Technical Comments on Electric Generating Unit Control Technology Options and
Emission Allocations Proposed by the Environmental Protection Agency
in Support of
the Proposed 2015 Ozone NAAQS Transport Rule

Midwest Ozone Group
National Rural Electric Cooperative Association
American Public Power Association

June 17, 2022

Figure 4-1. 2021 Average Ozone Season NOx Emissions: Tangential-Fired Boilers Firing Bituminous, Subbituminous, Blends and Lignite Coals

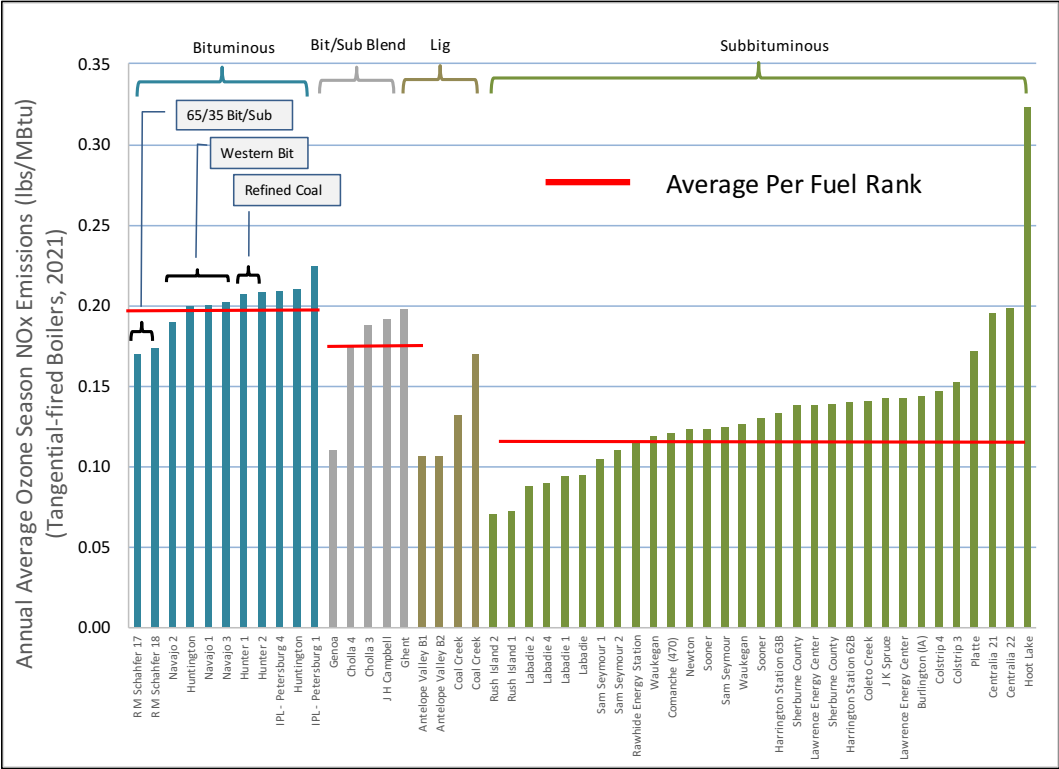
EPA identified 53 tangential-fired units and 39 wall-fired units equipped with advanced combustion controls. Figures 4-1 depicts for the EPA reference tangential-fired boilers the 2021 ozone season average of NO_x emissions as reported to EPA. Figure 4-2 depicts the 2021 ozone season NO_x average for the EPA reference wall-fired boilers. EPA proposes these units typify candidate units in the national fleet. This assumption is in err.

Figure 4-1 reports NO_x data for 11 tangential-fired units designated by EPA as firing bituminous coal, with the results suggesting approximately 0.20 lbs/MBtu as achievable. This depiction is inaccurate, as the fuels as reported by EPA as bituminous are misleading. Based on EIA Form 860 data for 2020, the RM Schaffer units fire a bituminous/subbituminous blend. The Navajo and Hunter units fired western bituminous – the composition of which lacks the sulfur content and acid/base ratio of eastern bituminous coals that are problematic in achieving the deep staged conditions required for low NO_x. Also, differences in coal nitrogen content and the inherent volatility assert an impact. The Hunter units fire a refined variant of bituminous coal – an option not available in 2022. Only IPL-Petersburg Units 1 and 4 fire an authentic bituminous coal of composition that could be considered representative of U.S. fuels. Further, EPRI estimates the median value of NO_x emissions from tangential-fired boilers firing bituminous coal to be 0.35 lbs/MBtu for LNCFS-II and 0.34 lbs/MBtu for LNCFS-III, with values for the latter option as high as 0.47 lbs/MBtu.⁹ This information – albeit derived from a 2003 summary – reflects the present status of technology cited by EPA, as the NO_x emission rates less than 0.10 lbs/MBtu were publicly cited in 2000.¹⁰

Figure 4-2. 2021 Average Ozone Season NOx Emissions: Wall-Fired Boilers Firing Bituminous, Subbituminous, Blends and Lignite Coals

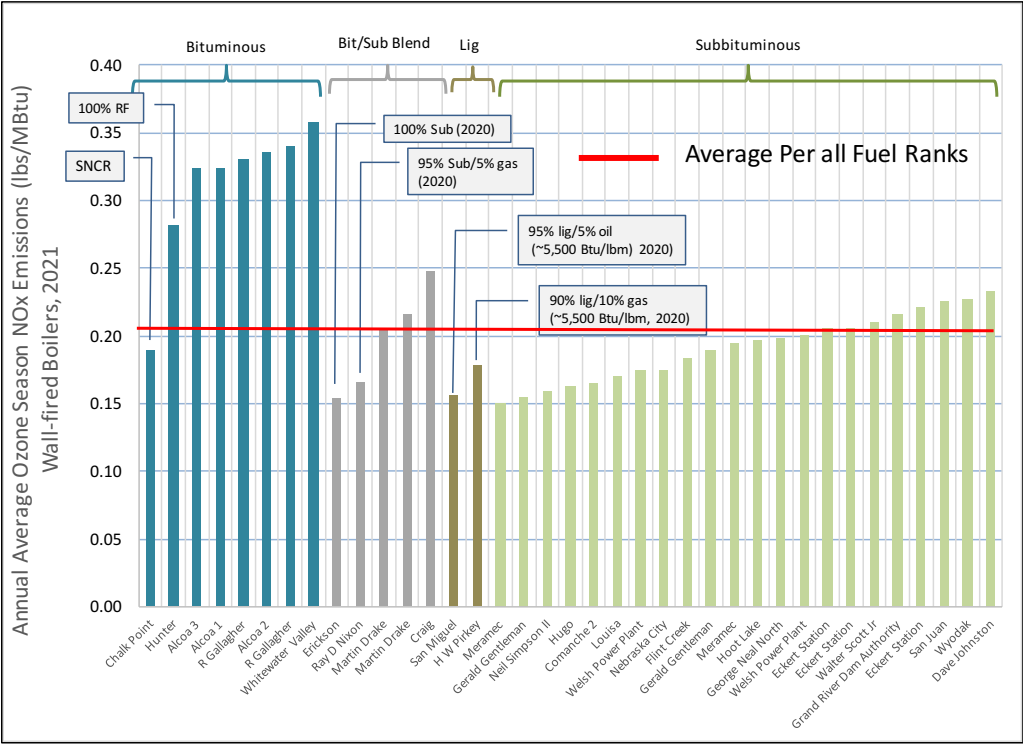
Figure 4-2 reports NO_x data for eight wall-fired boilers EPA cites as firing bituminous coal, with the results suggesting NO_x emission less than 0.20 lbs/MBtu as achievable. As noted

Figure 5-1. Capital Cost vs Capacity Relationship for SCR NOx Control: Coal and Distillate Oil/Natural Gas

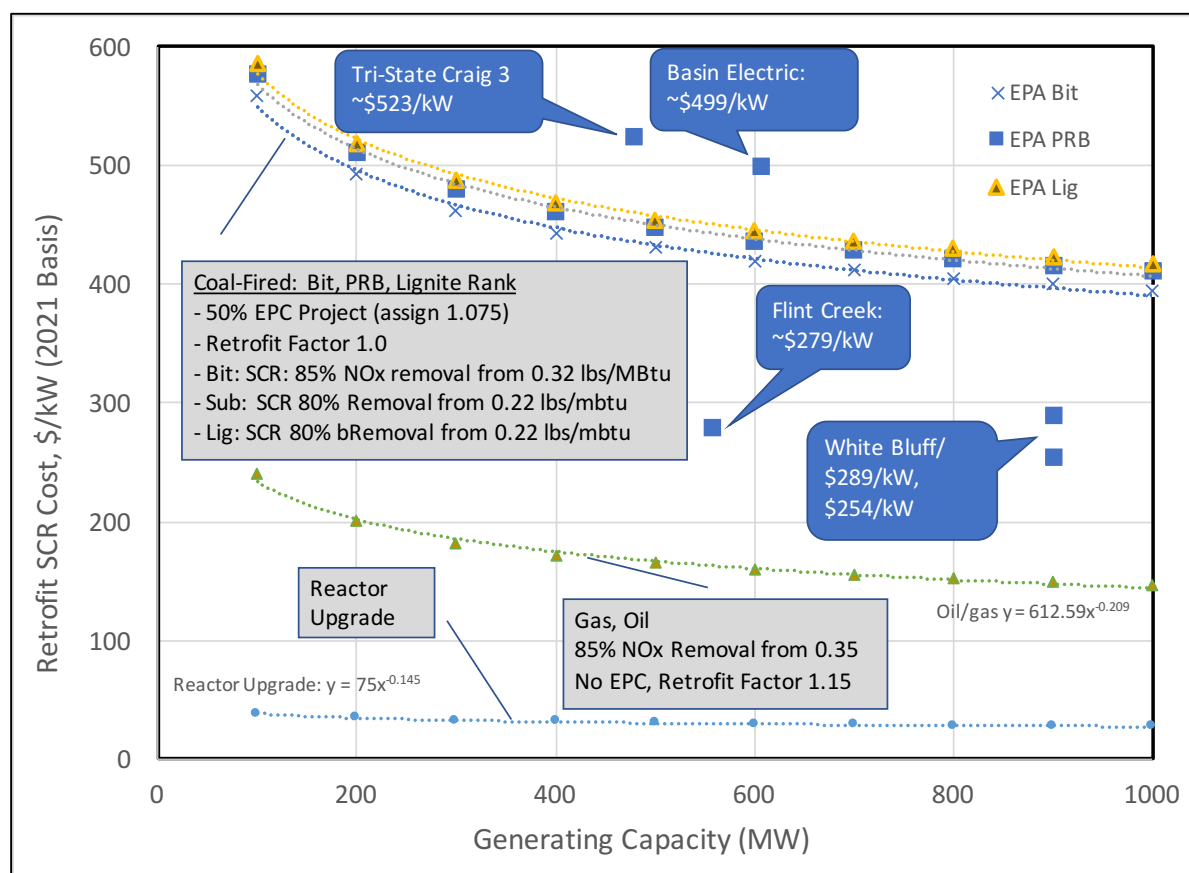
Figure 5-1 shows the cost correlation well-reflects four estimates recently prepared for project participants. That a factor-of-two variation observed between several of the estimates (Flint Creek, Craig Unit 3) is not unusual –industry experience shows such variations are not uncommon, due to varying site conditions. (Such variations are the rationale for the "Retrofit Factor", subsequently described).

Figure 5-1 presents SCR capital costs for units firing these three ranks of coal. The SCR process conditions and the percent NOx removal required are inputs to the Retrofit-Cost-Analyzer-Update-1-26-2022 to generate capital cost. For bituminous units, a boiler NOx rate of 0.32 lbs/MBtu is assumed, targeting 85% reduction. For both PRB and lignite fuel ranks, a boiler NOx rate of 0.22 lbs/MBtu is assumed, targeting 80% NOx reduction

Also included in Figure 5-1 is a cost of \$25/kW assumed necessary for pre-2005 SCR reactors to refurbish existing catalyst, retrofit enhanced catalyst cleaning devices (to remove accumulated fly ash deposits), and where necessary retrofit improved reagent mixing and flue gas rectification hardware (to improve flow velocity entering the SCR reactor). These or similar modifications will be necessary for pre-2005 SCR reactors to accommodate the changes proposed by EPA.

Figure 5-4. Timeline for Engineering, Procurement, and Installation of SCR Postcombustion Control Technology

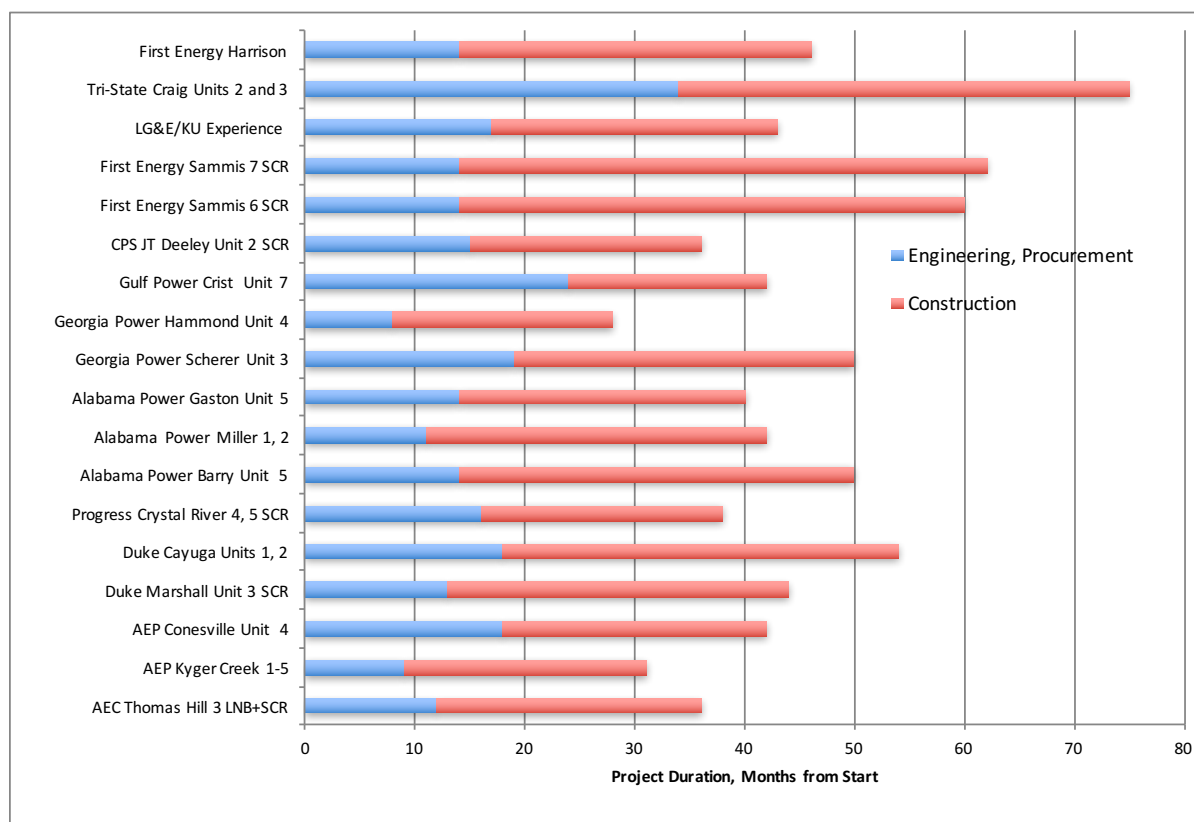
Figure 5-4 presents installation schedule information for 18 SCR installations, as managed by ten owners. These data capture all project aspects from planning, conceptual engineering, RFP development, proposal solicitation and review, contract award and negotiation, hardware fabrication and installation. Figure 5-3 shows the typical time required for a single SCR reactor is 40 months, while retrofit of multiple reactors to one site requires 45 months. These authentic, recorded schedules suggest that retrofit of the inventory of approximately 100 units with SCR technology is not feasible.

Even if the installation timeline could be accelerated, there are simply inadequate resources to deploy SCR to the extent required to meet the proposed rule. Figure 5-5 shows the projected increase in SCR inventory compared to historical work, showing that if all installations entered serve in 2026, the magnitude of installations would exceed that of 2003. The inventory could be staged over several years – as Figure 5-5 shows the SCR inventory required for 2005 was installed over 4 years.

Figure 6-1. SCR Retrofit to Coal-Fired Units: Incurred Cost per Ton, 10-Year Basis

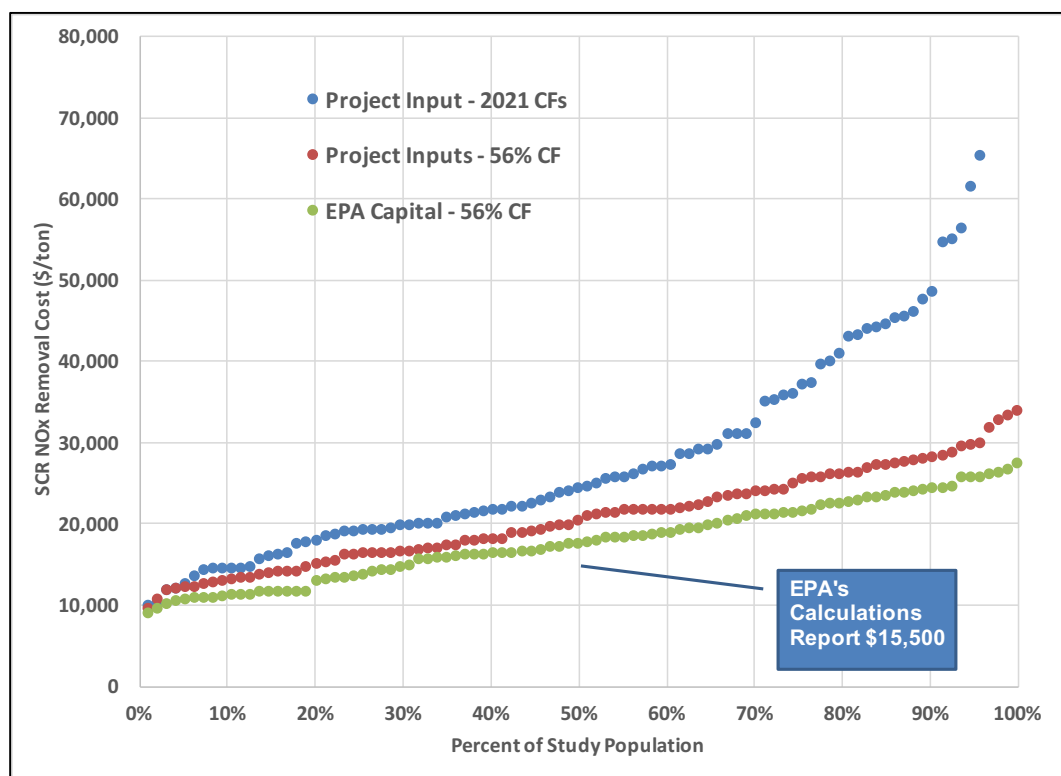
Figures 6-1 summarizes results derived in this study for the 143 units in the 25 states to which SCR is proposed to be retrofit, based on a EPA's assumed capital recovery factor of 0.143 and attendant presumption of a 10-year lifetime.³⁰ Also shown on Figure 6-1 is the cost per ton reported by EPA for their findings on the 35 states, using their assumed input conditions. The latter EPA-derived data is shown for units in the boiler population at the 50% (median) and 90% values. Figure 6-2 presents analogous results calculated for a 5-year remaining lifetime.

Figure 6-1 shows the median cost incurred for a unit to retrofit SCR where none had previously existed to be \$20,250 per ton for operation at 56% capacity factor, while 90% of units in the population will incur a cost not more than \$28,103 per ton. The analysis was also conducted for each generating unit using their unique 2021 capacity factor, with results showing the median cost for the population to be \$24,340 per ton, while 90% of units in the population will incur a cost not more than \$50,000 per ton.

Figure 6-2. SCR Retrofit to Coal-Fired Units: Incurred Cost per Ton, 5-Year Basis

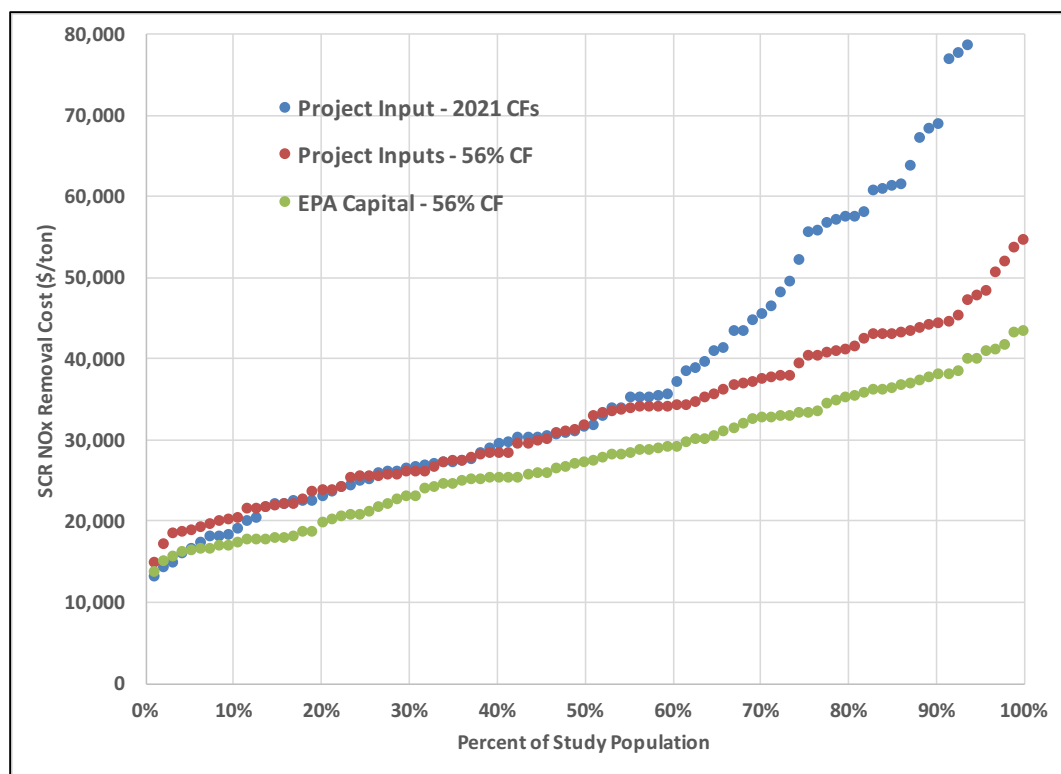
Figure 6-2 shows the decrease in lifetime from 10 to 5 years significantly increases cost. The incurred cost for a unit at the median population is projected to be \$31,663 per ton for operation at 56% capacity factor, escalating to approximately \$44,286 per ton for a unit at the 90% population. For operation at the 2021 capacity factor, the analysis shows the cost for the median population to be nearly identical at \$32,286 per ton, while 90% of units in the population will incur a cost not more than approximately \$70,000 per ton. The 5-year lifetime approximately doubles incurred costs.

Figure 6-7 Incurred Cost per Existing SCR to Achieve 0.08 lbs/MBtu

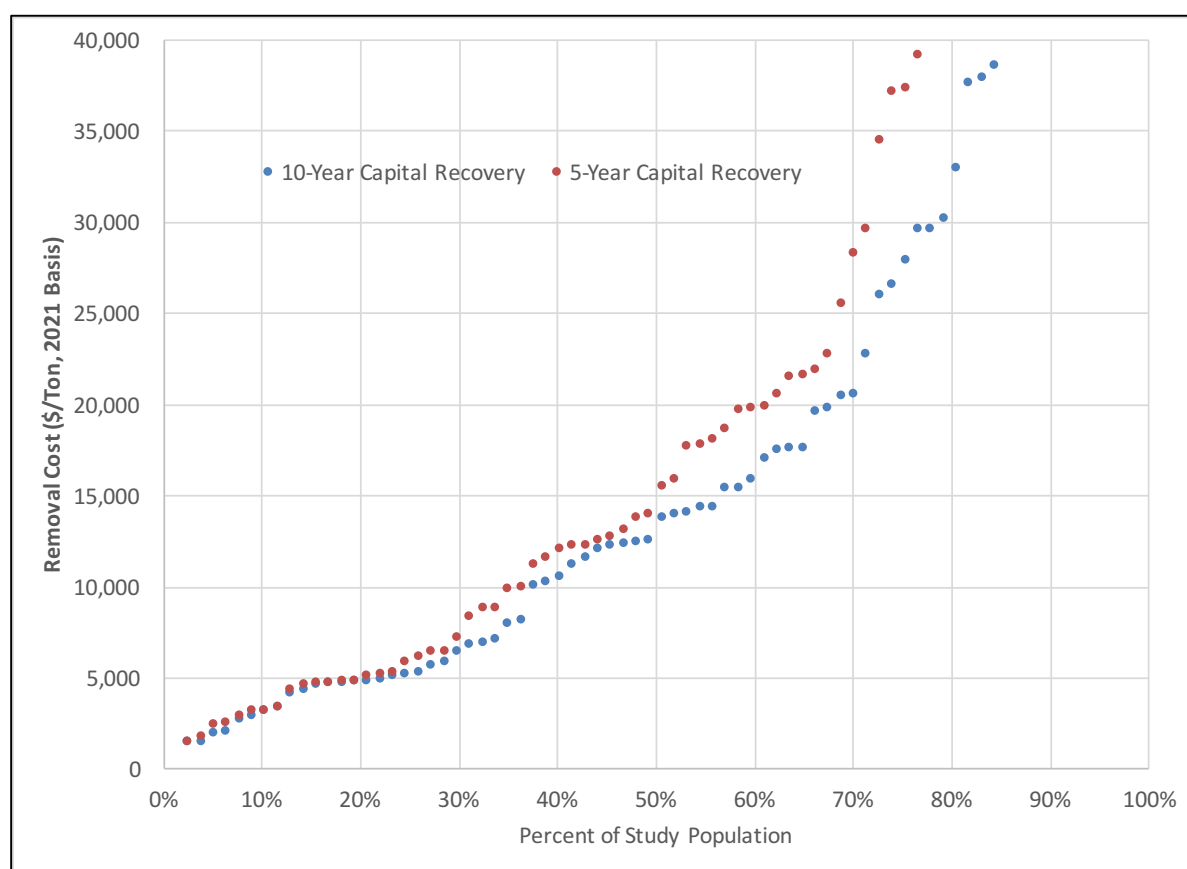
Figure 6-6 presents results for the study population of 94 units from the 25 states. Data are shown for a 5 and 10-year recovery period for the nominal investment (approximating \$25/kW) for units that entered commercial duty prior to 2005. These results show the median cost is approximately \$14,000-\$15,000 per ton; 90% of units in the population will incur a cost not more than approximately \$40,000 per ton.

Figure 6-7 presents the true cost EPA should be using as the metric - the marginal cost for the incremental reduction in NO_x from the 2021 ozone season rate achieved by SCR. Absent EPA actions, this 2021 NO_x rate would continue – thus enhancing SCR performance to meet 0.08 lbs/MBtu (with margin) is an additional benefit. The methodology to determine this cost is the proper approach to value the cost of this aspect of the proposed rule.

Figure 7-2. LG&E/KU Mill Creek Unit 4 Startup Data

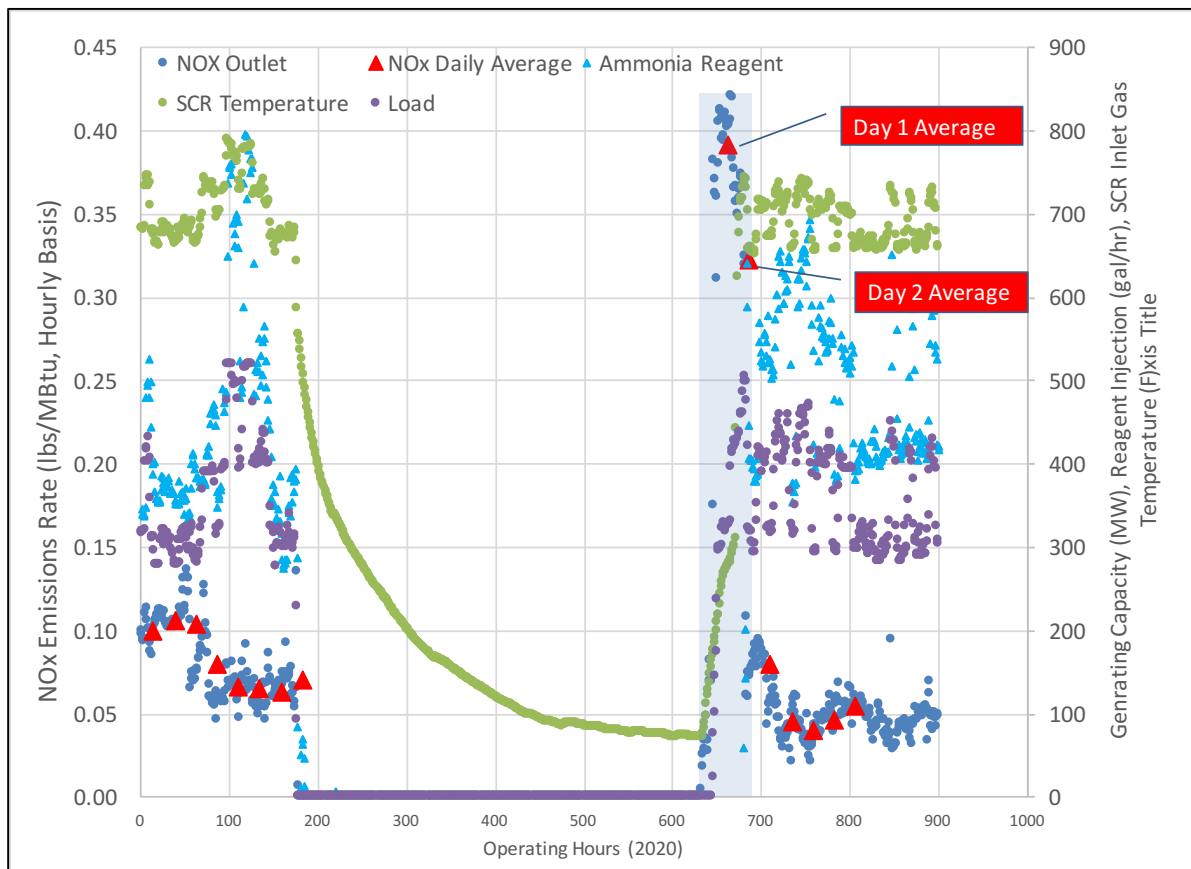
Figure 7-2 presents a timeline of data observed in May of 2020 from an actual process startup for LG&E/KU Mill Creek Unit 4, a bituminous wall-fired unit. The outage from which Unit 4 is emerging up reflects a typical ‘pre-ozone season’ outage, essential to inspect catalyst and equipment for reagent injection. The NO_x emission rate is recorded through the startup and reflected on the left axis, while the ammonia reagent (gallons/hr), load (MW), and reactor temperature (°F) are reported on the right axis. Also shown is the daily NO_x average, constructed per EPA boiler operating day data.

Figure 7-2 shows that at least for two boiler operating days following ammonia injection, the daily NO_x rate exceeds the proposed backstop value of 0.14 lbs/MBtu. Consistent with Figure 7-2, EPRI reports typical SCR startup periods are 7-24 hours, and impact the ability of the SCR process to effectively remove NO_x.³⁴

Figure 7-3. LG&E/KU Trimble County 2: Time Duration of SCR Startup Events

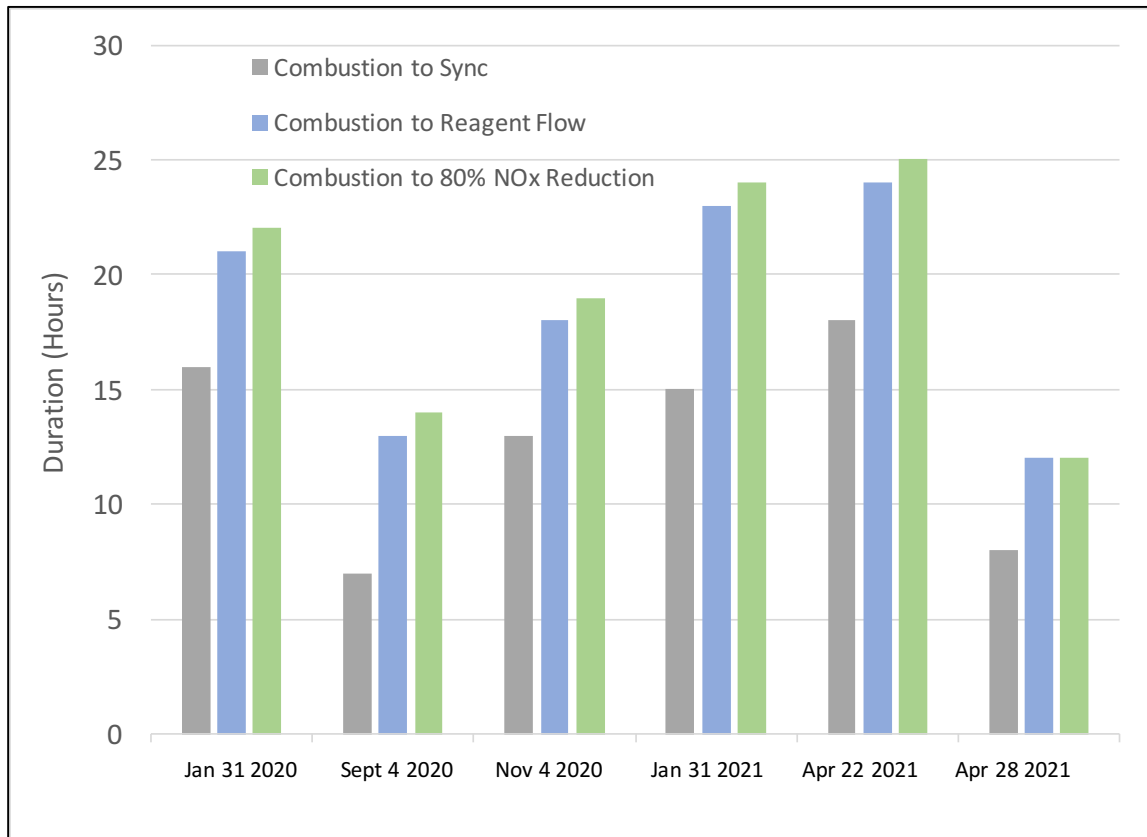
Additional insight as to the role of startup on delaying operation of SCR and control of NO_x emissions is reflected data from six startup events experienced by LG&E/KU Trimble County Unit 2, from January 31 2020 to April 28 2021. Figure 7-3 presents a bar chart summarizing the time required for from establishing combustion to (a) “sync” with the power grid, (b) initiate reagent flow, and (c) to achieve 80% NO_x reduction.

The key takeaway from Figure 7-3 is the time required for 80% NO_x reduction, which over six startup events ranges from 12 to 25 hours.
